ADA Curb Ramp New Construction Inspection Form (Combination)

NW 307th

23885.56

NW Kaybern

COMBINATION RAMP (C)

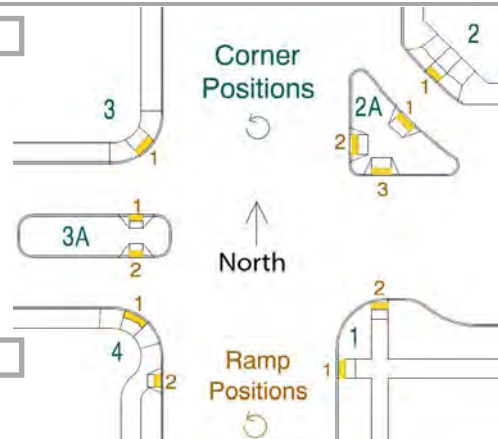
☒

☒

☒

☒

DWS IITD, TS Large Crack, Puddle in gutter at Ramp
